Car Stereo Service Bulletin

Model: CDX-5040/5080/7520/7540/7560/7580

No. 222

Subject: Service Manual Correction: PLL Free Run Adjustment

[RF BOARD]

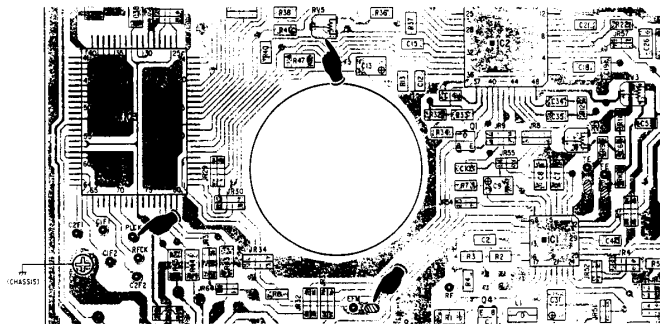
The PLL adjustment shown in the Service Manuals is incorrect.

Use the procedure listed below to perform this adjustment.

1. Do not insert the test disc.
2. Remove the solder bridge at test point EFM.
3. Connect a frequency counter to test point PLCK.
4. Press the power button.
5. Test mode setting:
 - a. For microcomputer IC501 μ PD75516GF-107-3BQ: Press the RESET button while keeping the MUTE and the 1 keys on.
 - b. For microcomputer IC501 μ PD75516GF-160-3BQ: Press the RESET button while keeping the MUTE and LOUD keys on.
6. Press the PLAY button.
7. Adjust RV5 for 4.3218MHz \pm 0.01MHz on the frequency counter.
